DEVELOPMENT REVIEW BOARD
SUPPLEMENTAL SUBMITTAL

PROJECT NO. PR-2021-005459
Application No. SD-2021-00163 SI-2021-01248

**RE: PR-2021-005459 RESPONSE TO DRB COMMENTS
LOT 1A BLOCK 2 & LOT 2-A-1 BLOCK 2 SUNPORT PARK
2900 TRANSPORT ST NE**

ENGINEER'S SEAL TRANSPORT HOUSING TRANSPORT ST & FLIGHTWAY AVE	DRAWN BY BF DATE 8/3/2021
	MASTER UTILITY PLAN	2020072_MUB
 TIERRA WEST, LLC 5571 MIDWAY PARK PLACE NE ALBUQUERQUE, NM 87109 (505) 858-3100 www.tierrawestllc.com	SHEET # C3	JOB # 2020072

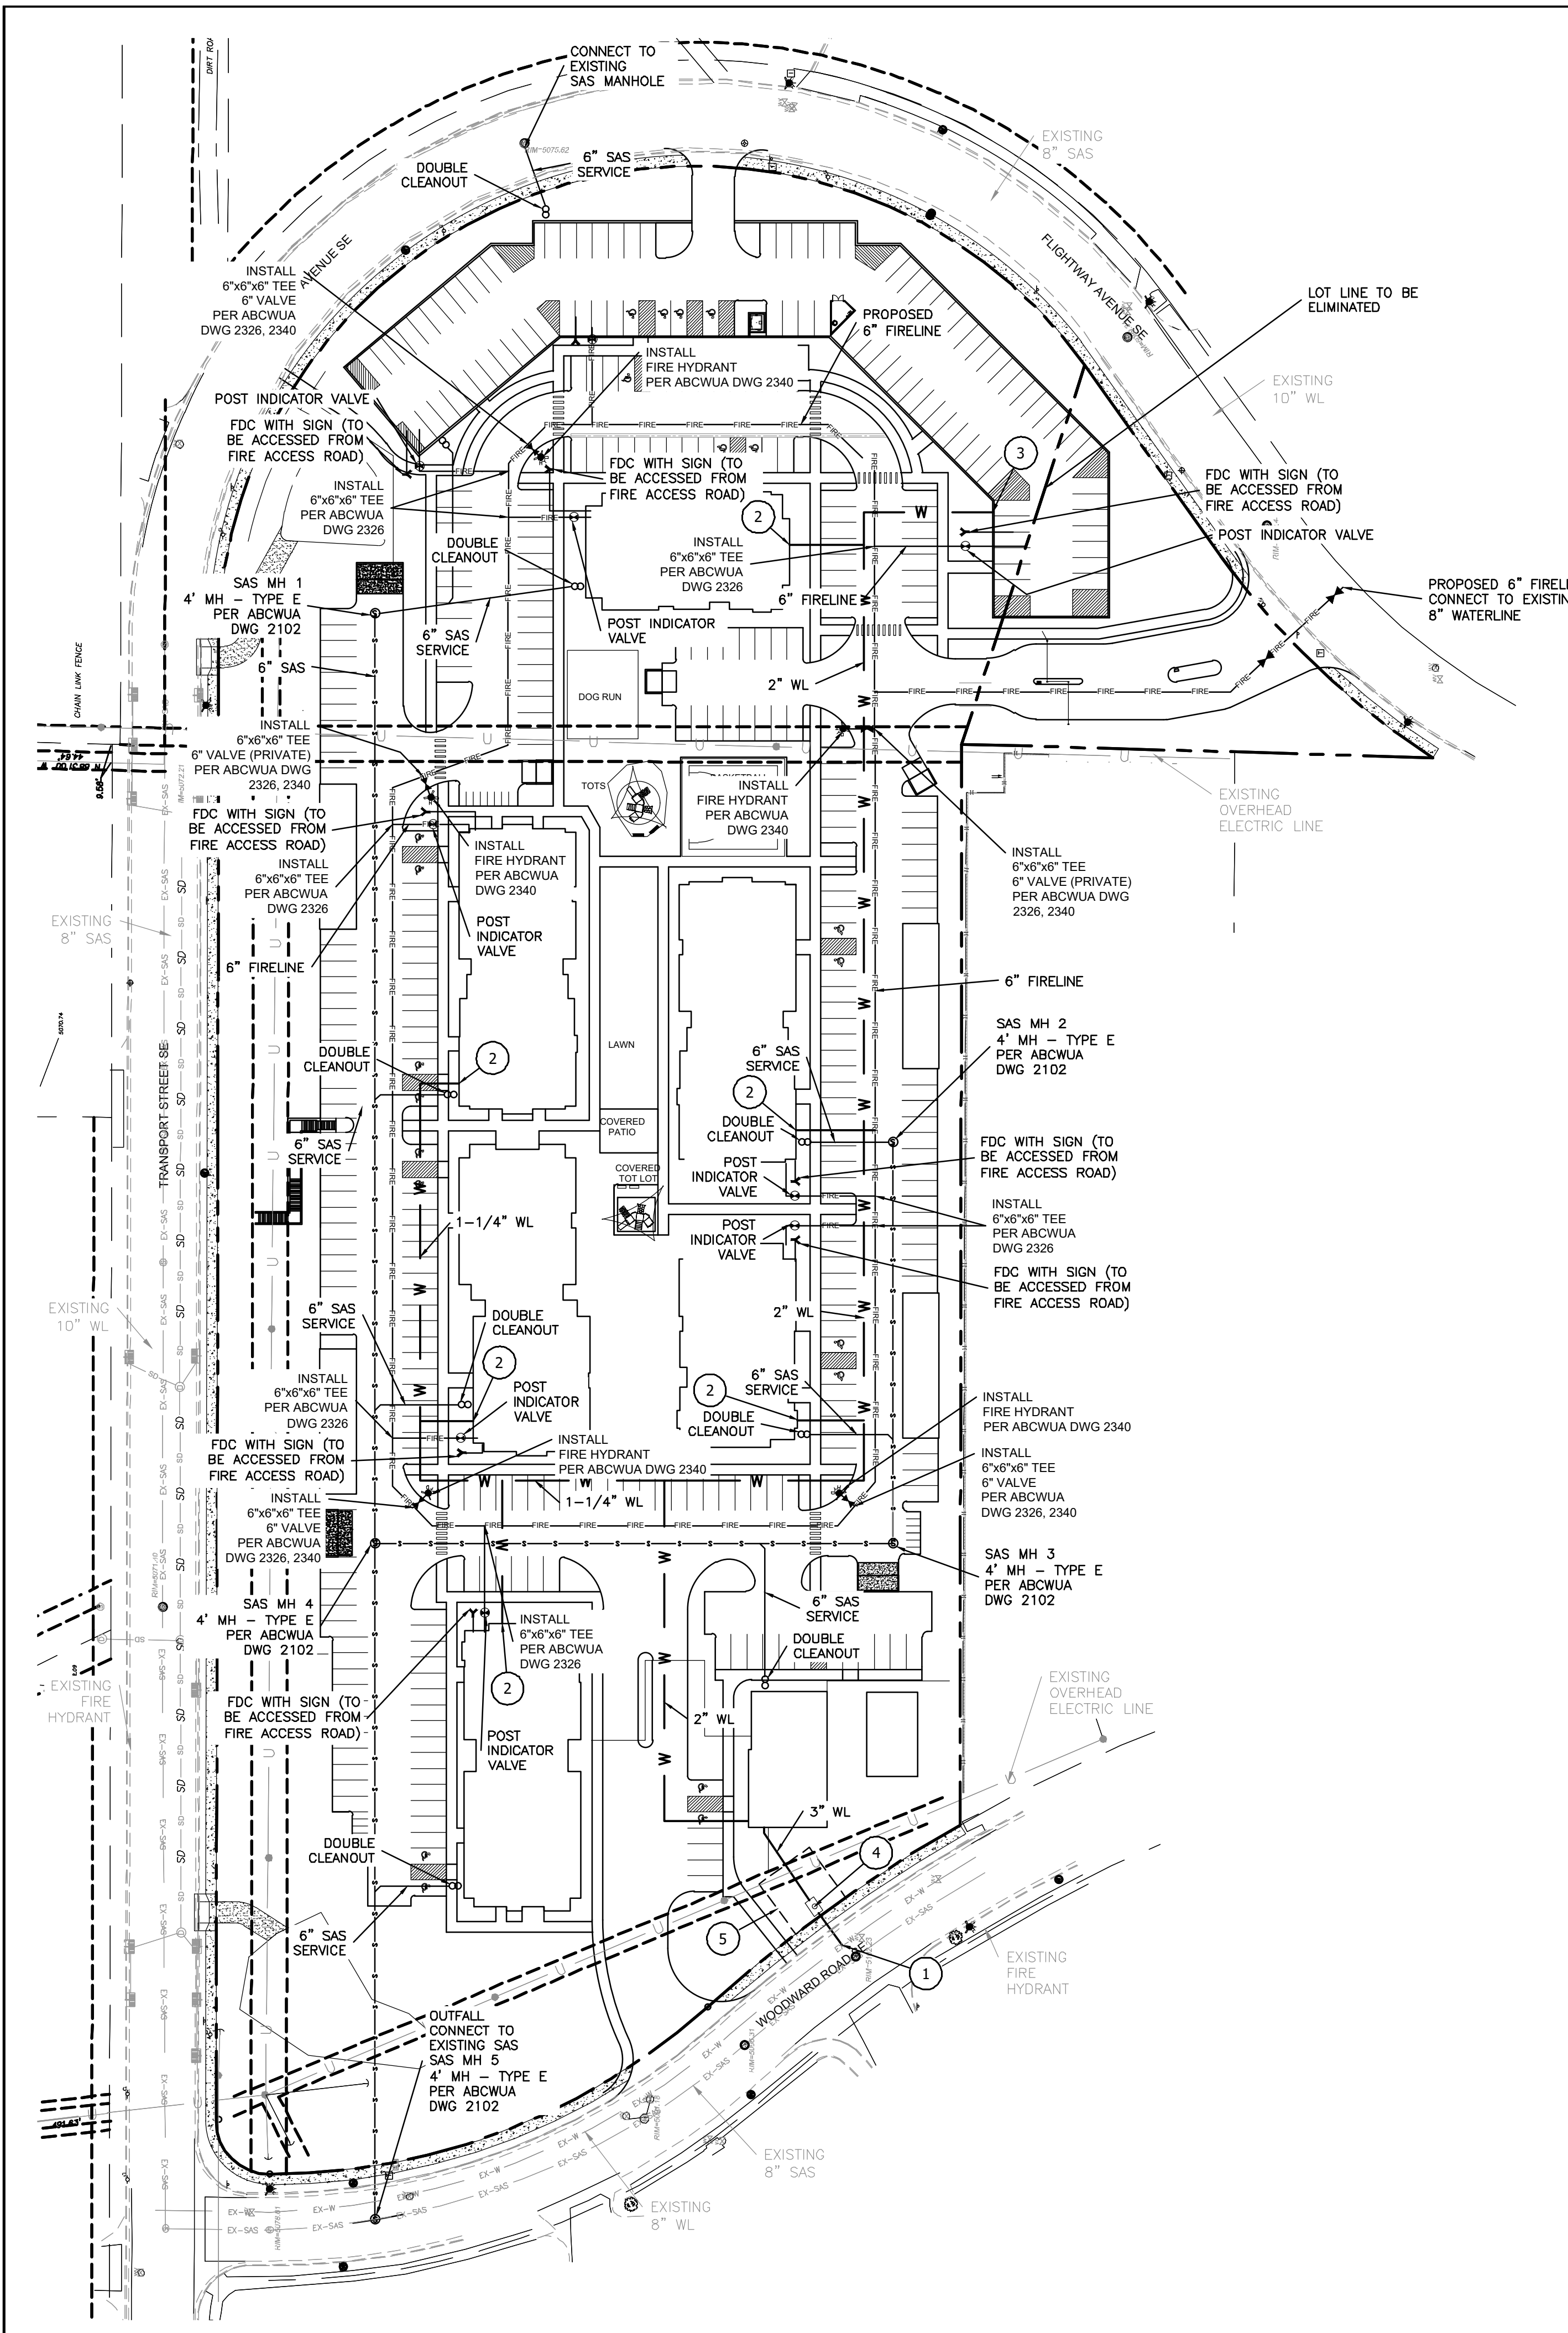
2. The proposed fire line has two connections to the public main and is internally looped. This is not allowed. The lines should be separated such that they do not interconnect on site.

RESPONSE: Noted. We are not anticipating this development to be separated out into multiple parcels once constructed and in residential use.
4. Exclusive public water and sanitary sewer easements are required for all public lines that are to be constructed outside of any dedicated rights-of-way. A minimum width easement of 20' is required for a single utility and 25' for water and sewer both within the same easement. Easements for standard sized water meters need to be 5' x 5' and include the length of the water service if located on private property. For larger meters that require a meter vault, a 35' x 35' easement is required. Actual easement widths may vary depending on the depth of the lines to be installed.

RESPONSE: The Utility Plan, Sheet C3, has been updated for only showing a single connection to the main on Flightway Ave. The southern fire line connection to the main on Woodward Rd has been eliminated.

RESPONSE: All water and sanitary sewer lines to be built onsite are to be private. A 35' x 35' public water easement is being granted on the replat for the 3" water meter vault. This easement is also shown on the Utility Plan, Sheet C3, and is called out with Keyed Note 5.
